Work Order ID 77199***77199***

Item Name: Crosstube Turning Detail

DESIGN	PH	DART AEROSPACE LTD	
DRAWN	RF	HAWKESBURY, ONTARIO, CANADA	
CHECKED	JP	DRAWING NO.	REV. E
MFG. APPR.	JP	D412-664-243	SHEET 2 OF 4
APPROVED	JP	TITLE	SCALE
DE APPR.	JP	CROSSTUBE ASSEMBLY (412 HI AFT)	NTS
DATE	09.09.30	<small>COPYRIGHT © 2001 BY DART AEROSPACE LTD THIS DOCUMENT IS PRIVATE AND CONFIDENTIAL AND IS SUPPLIED ON THE EXPRESS CONDITION THAT IT IS NOT TO BE USED FOR ANY PURPOSE OR COPIED OR COMMUNICATED TO ANY OTHER PERSON WITHOUT WRITTEN PERMISSION FROM DART AEROSPACE LTD.</small>

DRAWING NO. D412-664-243	TITLE CROSSTUBE ASSEMBLY (412 HI AFT)	REV. E	DART AEROSPACE LTD ENGINEERING ORDER		D.E.O. NO. D412-664-243-E-1	SHEET NO. SHEET 1 OF 2	SCALE NTS
DRAWN	CHECKED	MFG. APPR.	APPROVED		DE APPR.		
DATE 11.03.31	DATE 11/03.31	DATE 11.03.31	DATE 11/03.31		DATE 11.03.31

D212-664-243
ASSEMBLY DETAIL

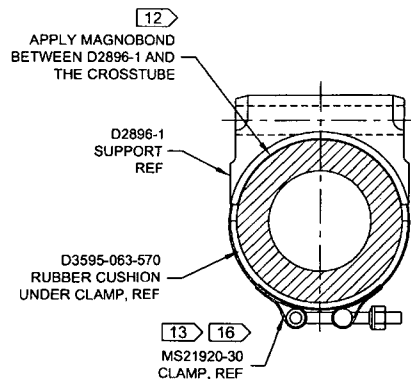
REMOVED ABRASION STRIP IN FAVOR OF A THIN LAYER OF PROSEAL 890.

PARTS LIST IS AMENDED AS FOLLOWS:

Item	Qty -243	Part Number	Description
6	0	D2856-600-1009	ABRASION STRIP

6	2	D2856-600-1009	ABRASION STRIP
---	---	----------------	----------------

- 2) FINISH: CHEMICAL CONVERSION COAT PER DART QSI 005 4.1
PRIME INSIDE AND OUTSIDE PER DART QSI 005 4.2
MASK UNDERSIDE OF CROSSTUBE AS SHOWN (HATCHED AREA)
PAINT OUTSIDE PER DART QSI 005 4.2
AFTER PAINTING, APPLY CLEAR COAT ON HATCHED AREA
- 14) APPLY A THIN COAT OF PROSEAL 890 ON INSIDE CONCAVE SURFACE OF D3189-1
CHAFING SHIELD AND LET CURE PER MANUFACTURER'S INSTRUCTIONS. INSTALL
PROSEAL D3189-1 CHAFING SHIELD ONTO CROSSTUBE BY APPLYING A THIN COAT OF
PROSEAL 890 ONTO CROSSTUBE. BE SURE TO ELIMINATE ANY AIR GAPS.

- 2) FINISH: CHEMICAL CONVERSION COAT PER DART QSI 005 4.1
PRIME INSIDE AND OUTSIDE PER DART QSI 005 4.2
PAINT OUTSIDE PER DART QSI 005 4.2
- 14) INSTALL D2856-600-1009 ABRASION STRIPS WITH A 0.13 REF GAP ON BOTTOM SIDE OF
CROSSTUBE PER QSI 035.
